DECISIONS AND ACTIONS

Steering Committee
Wednesday, November 21, 2018

Presentation: McKenzie Interchange outfall proposed wetland water quality treatment – Sean Wong, Manager, Biological Programs, Ministry of Transportation and Infrastructure (See Appendix 1)

McKenzie Interchange SE Outfall Proposed Wetland Water Quality Treatment For Gorge Waterway Initiative Nov. 21, 2018

Riprap Lined Outlet Swale Through Riparian Zone Rejected

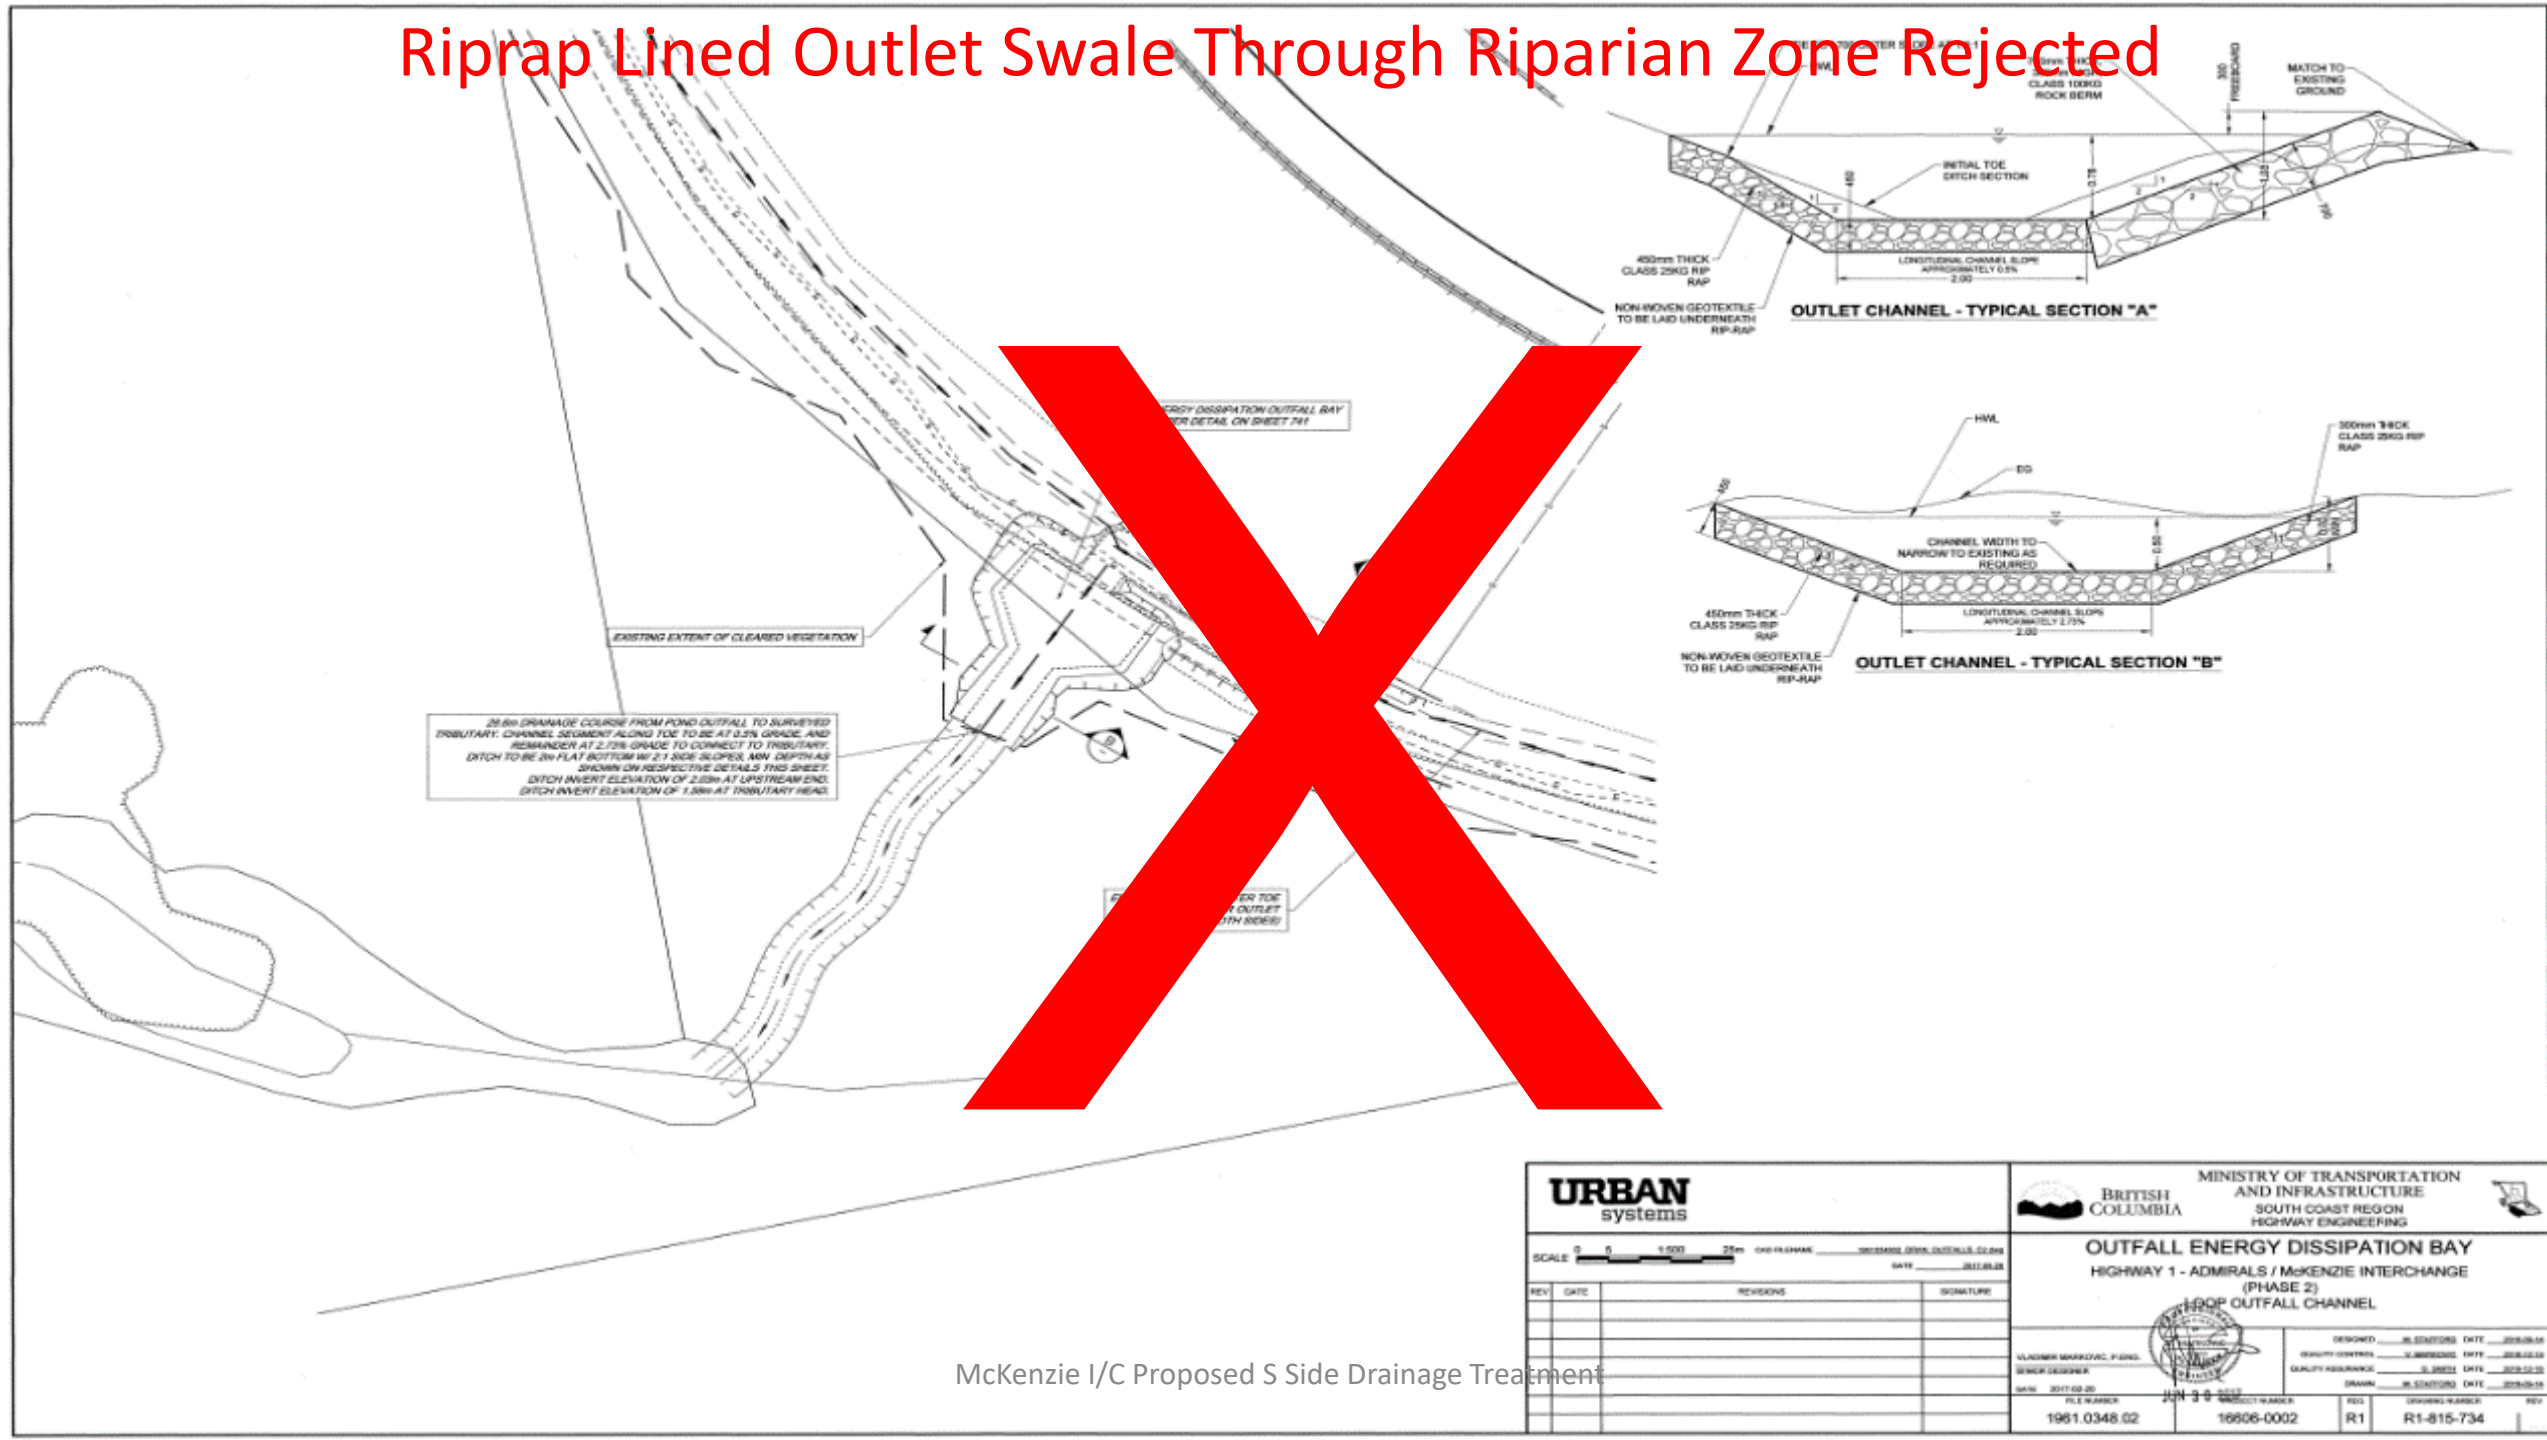
- Rather than making it more hospitable for fish, considering biological treatment, to clean the water and polish before it flows into estuary
- Originally considered a rock lined culvert channel, but this was considered over-engineered, and was later nixed

McKENZIE INTERCHANGE WATER QUALITY TREATMENT POND PLAN, PROFILE AND X-SECTIONS

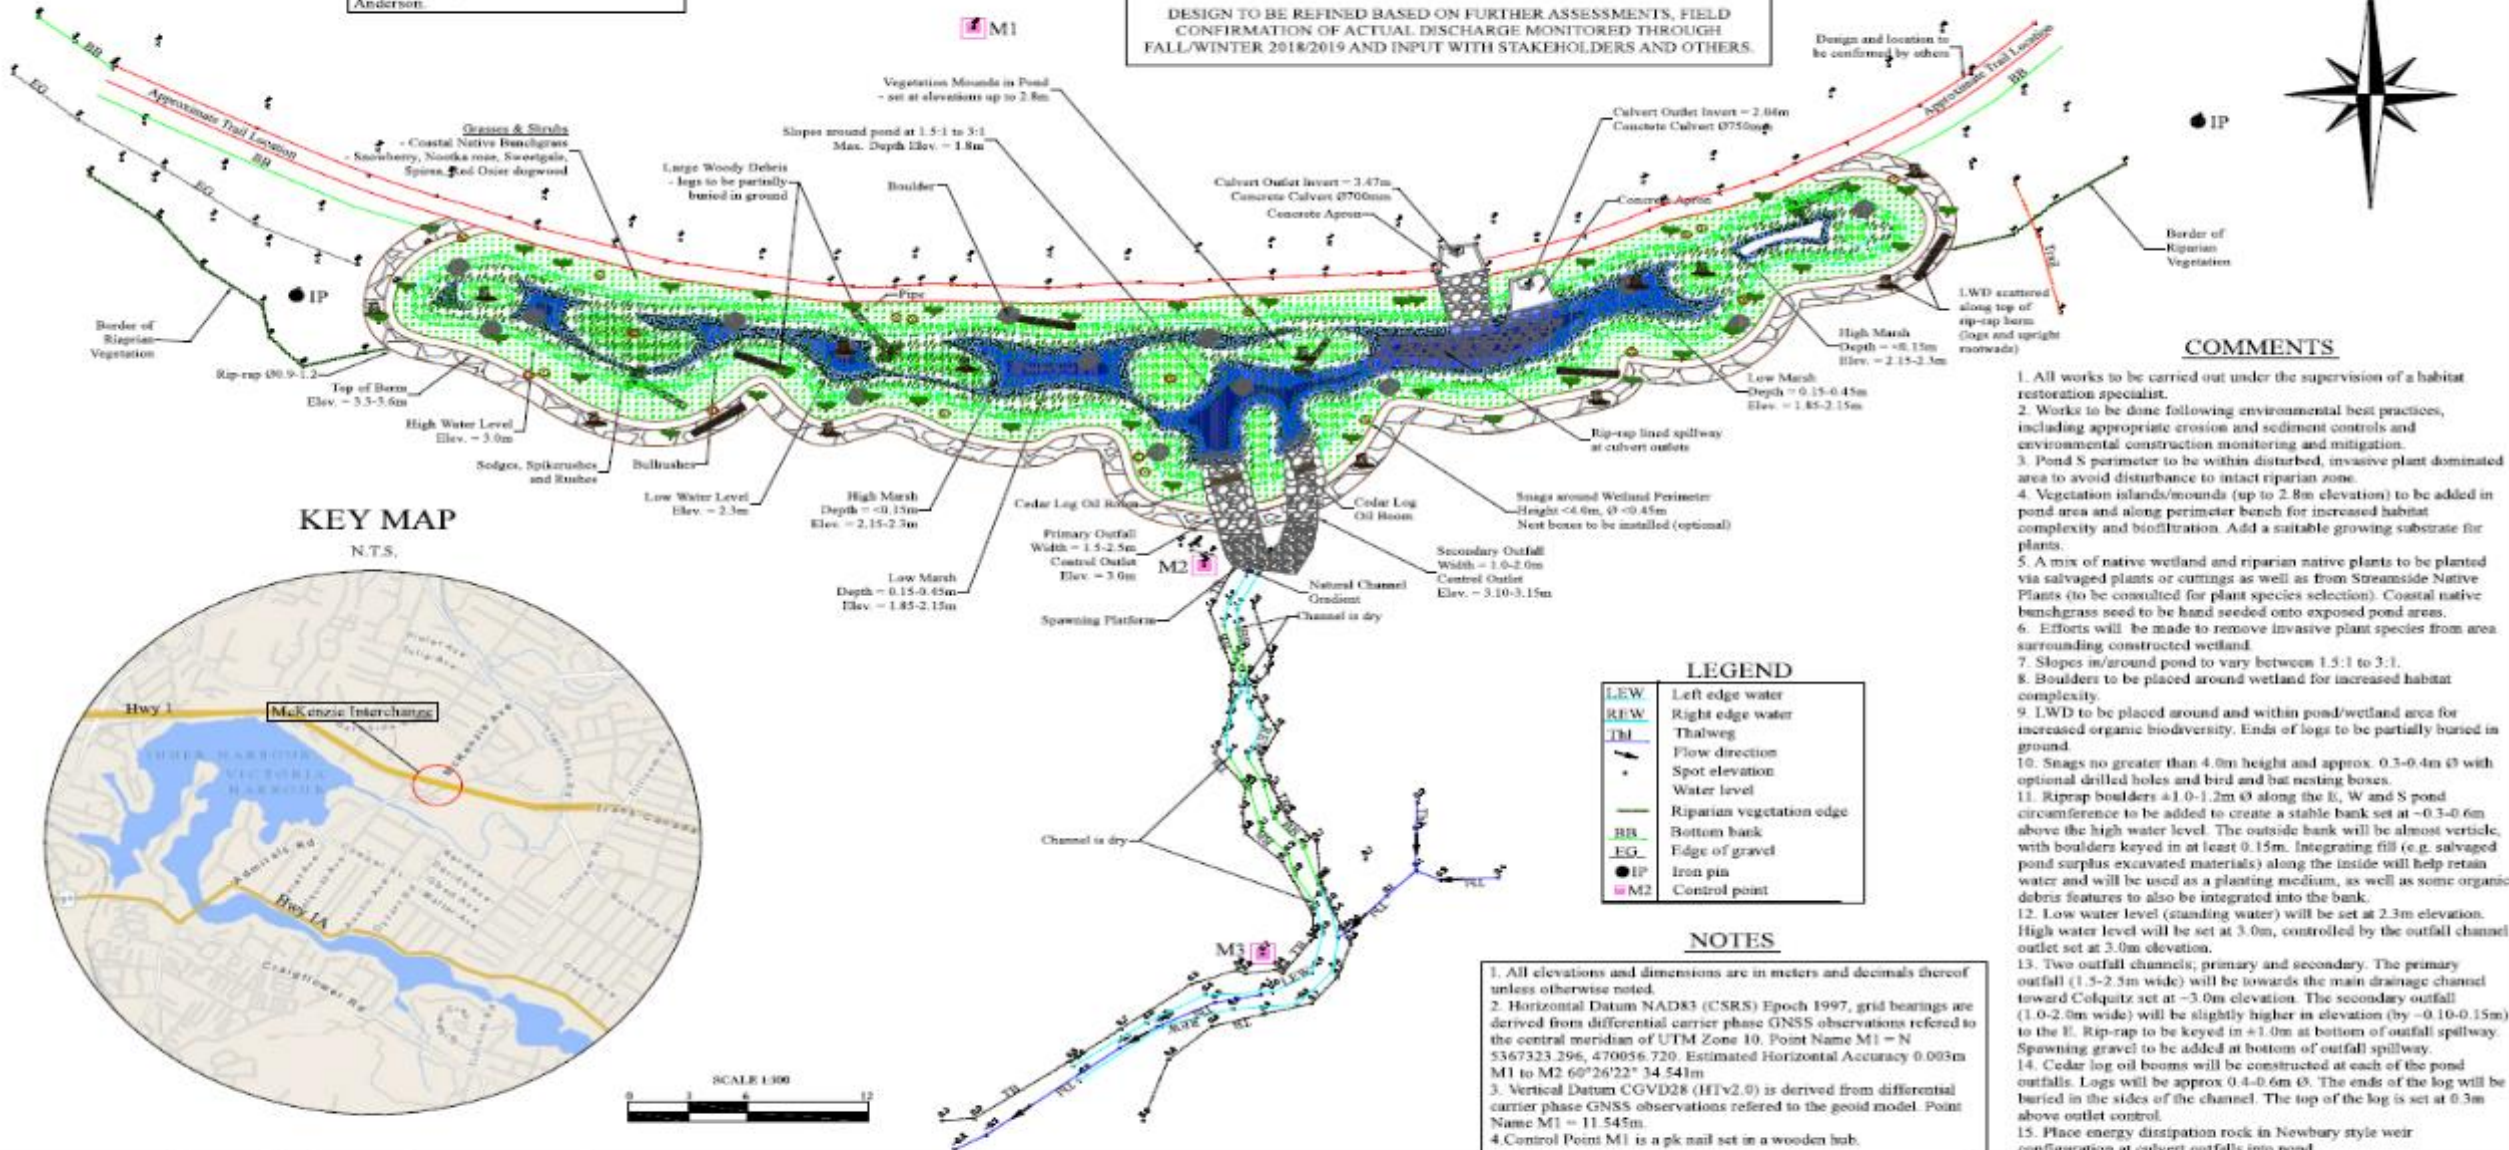
Comment: This is a vast improvement from what was originally proposed

Q: What about using oyster shells to absorb some heavy metals from stormwater?

Q: Access into the park from adjacent parking lot?

Q: From experience at location where highway crosses Craigflower Cr, wondering how the oily debris and spills will be treated or prevented from entering the creek?

A: Open to ideas, want to slow the runoff and allow plants to biofilter contaminants

A: will need to be integrated into the pond as there is very little room (5 – 10m strip). Proposing to make access up on the slope rather than crossing the channel with a footpath. Pond will be 5 – 10m wide, 75 m long parallel to the curved cloverleaf

A: baffle type system in the cloverleaf, wanting to collect the surficial materials and skim it off. Once the pond has vegetation established, plants will slow the flow and clean the runoff

Cedar Log Oil Boom/Skimmer - Construction Diagram

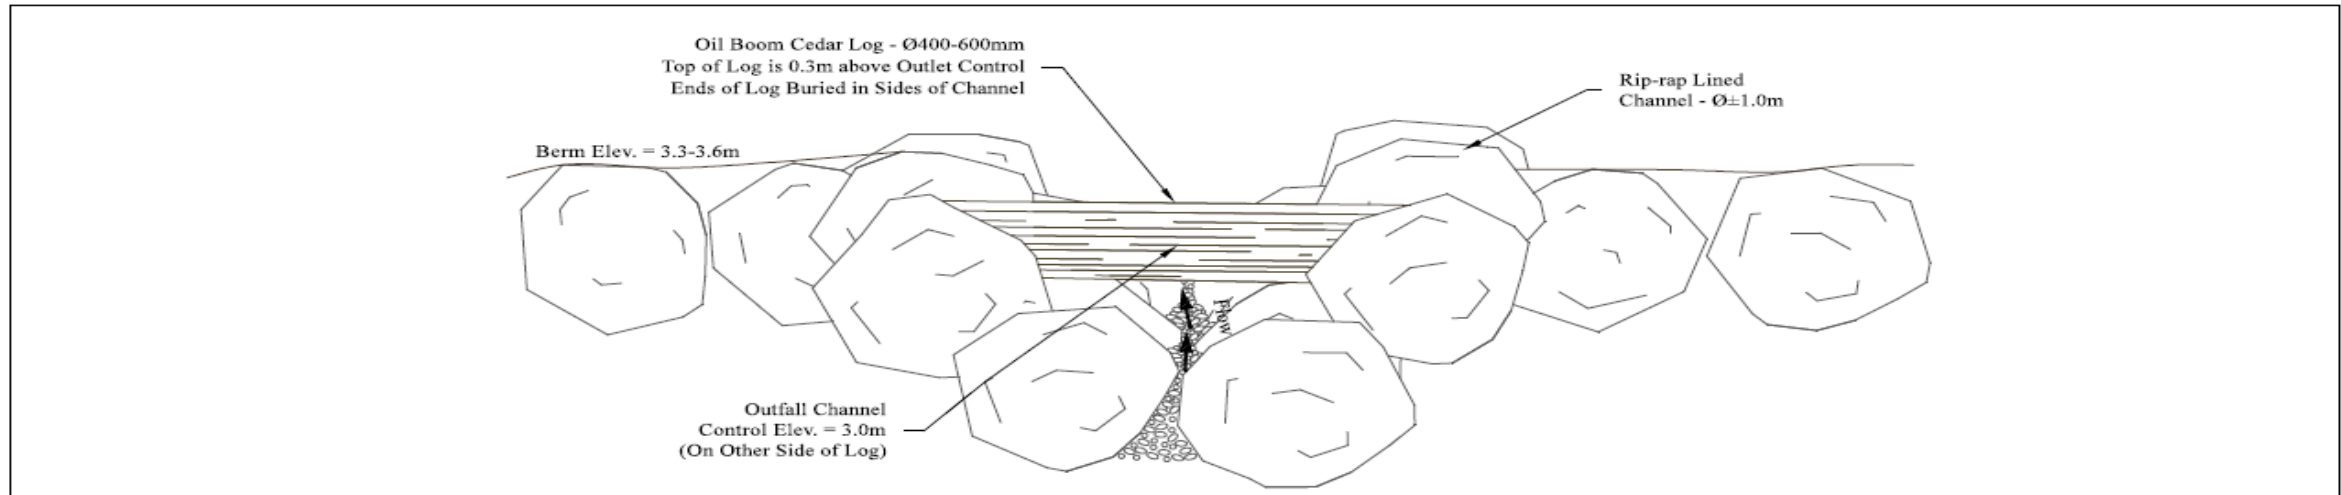
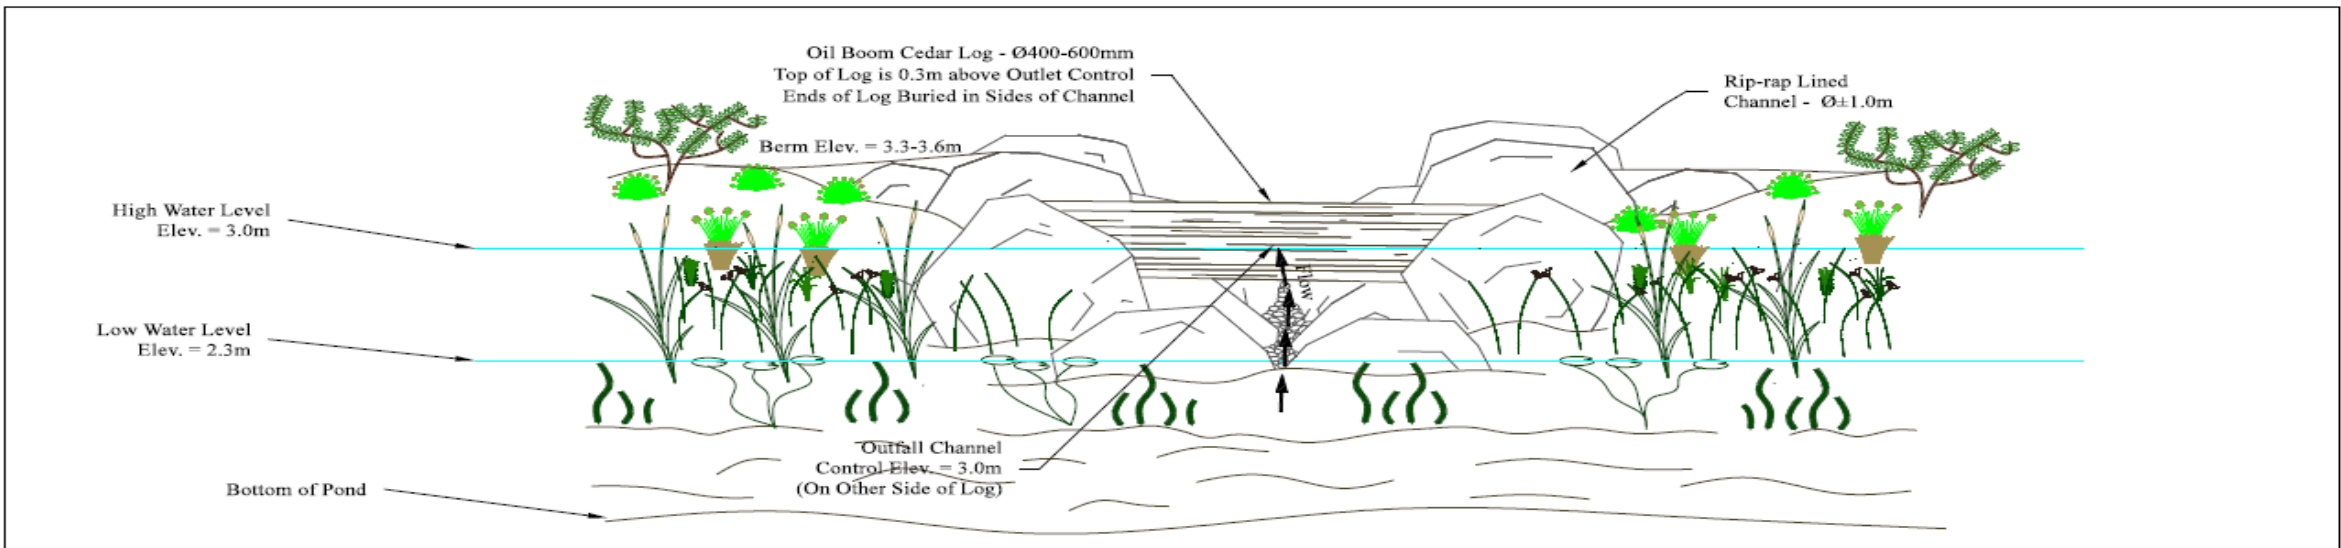
- Will need to build up a perimeter bank, so that fish can't access it
- Looking at oil skimmers and other options for containing any potential fuel slicks or spills: e.g. install a log in outlet channel so that anything floating is skimmed and kept in the pond
